FACILITY: Grand Gulf Nuclear Station, Unit 1

SUBJECT: SUMMARY OF APRIL 16 AND 17, 1990 MEETING WITH ENTERGY OPERATIONS,
INC. REGARDING BUILDING SETTLEMENT MONITORING

GRAND GULF NUCLEAR STATION
REQUEST FOR ADDITIONAL INFORMATION (RAI)
STRUCTURAL & GEOSCIENCES BRANCH/DET/NRR
(REVIEWER: RAMAN PICHUMANI)

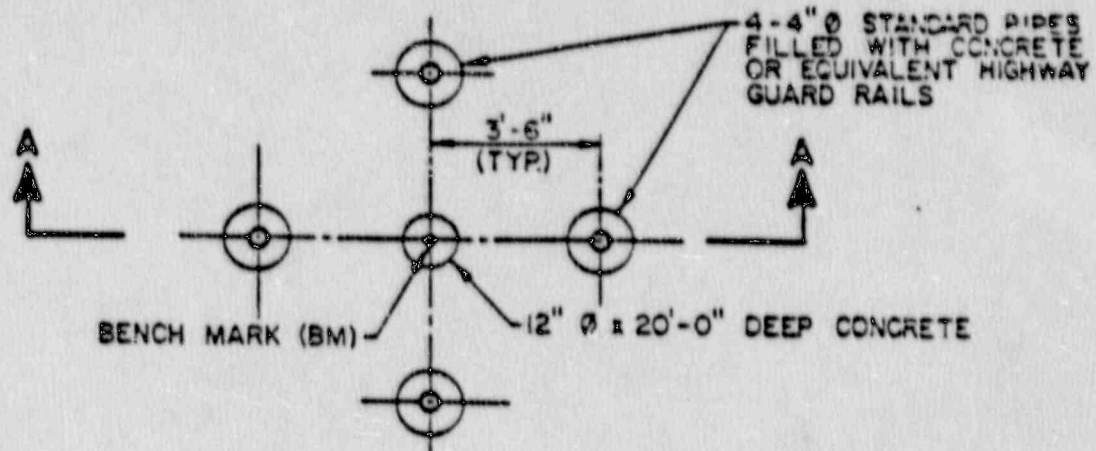
2.a) Explain the reasons for the destruction of settlement markers and for the unavailability of settlement data for extended periods of time in the case of some Category 1 structures as noted from FSAR Fig. 2.5.4-75.

- o February 1982 thru October 1983
 - o No FSAR guidance on post construction required survey.
 - o Survey was performed once per year except for P-7, P-11, P-13, P-52, and P-53.
- o P-7 - Diesel Generator Building
 - o Missed on 8/82 survey due to inaccessibility
 - o Relocated in 4/84.
 - o Tied back to existing point.

CONTAINMENT POINTS P-11 & P-13

- o Missed between 1/82 - 4/84**
- o Points are not accessible due to location.**
- o 4/84 - Re-established in an accessible location.**
- o Tied back in using other accessible points in the Auxiliary Building.**
- o Very minimal change in Auxiliary Building elevations in this time period.**

GROUNDWATER MONITORING

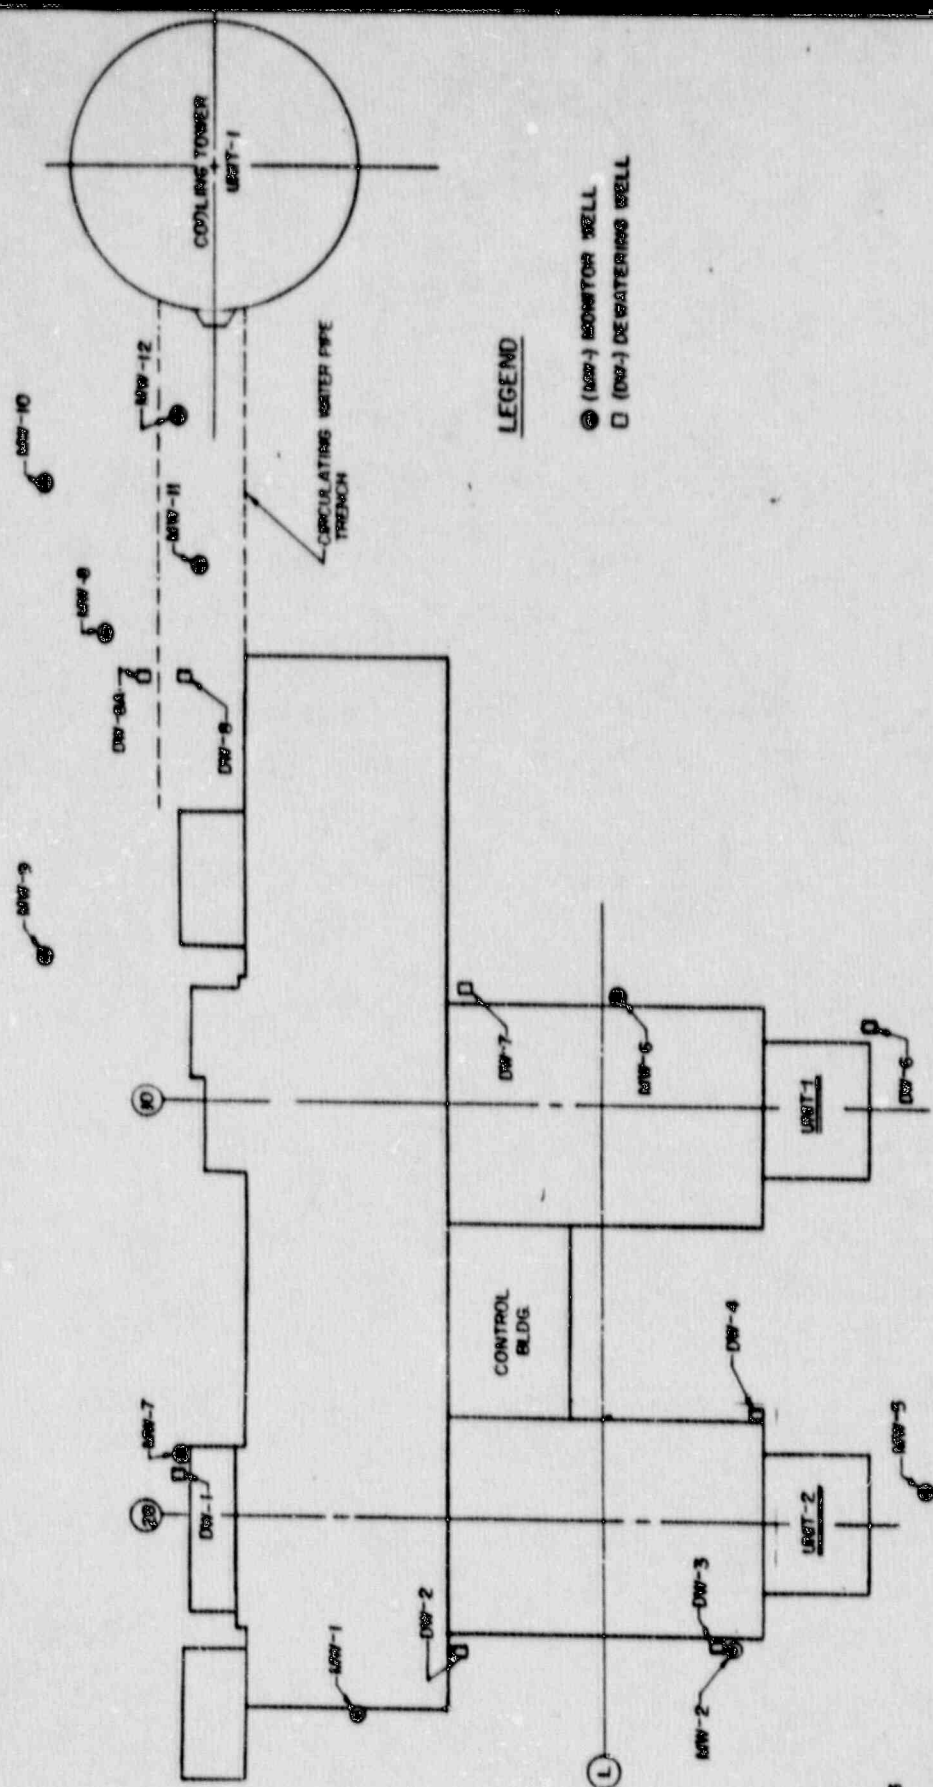
- 3. Discuss the results of groundwater monitoring at the site and provide an evaluation of the affects of fluctuation in groundwater levels, if any, on the stability and settlement of structures.**

- o Per FSAR and SER maximum groundwater level established at Elevation 109.0 MSL**
- o Level for Unit 1 monitored at 1 month intervals**
- o January 1983 level exceeded Elevation 109 MSL**
- o December 1983 - Performed a Study of exceedance**
- o February 1985 - submitted study to NRC, with exceedance attributed to:**
 - o Excessive precipitation at the site**
 - o Lack of completion of U2 structure**
 - o Lack of completion of clay seal**
 - o General yard area grading not completed**
 - o Increased infiltration from natural causes**
- o Analysis shows high groundwater acceptable up to Elevation 114.5 for all buildings.**
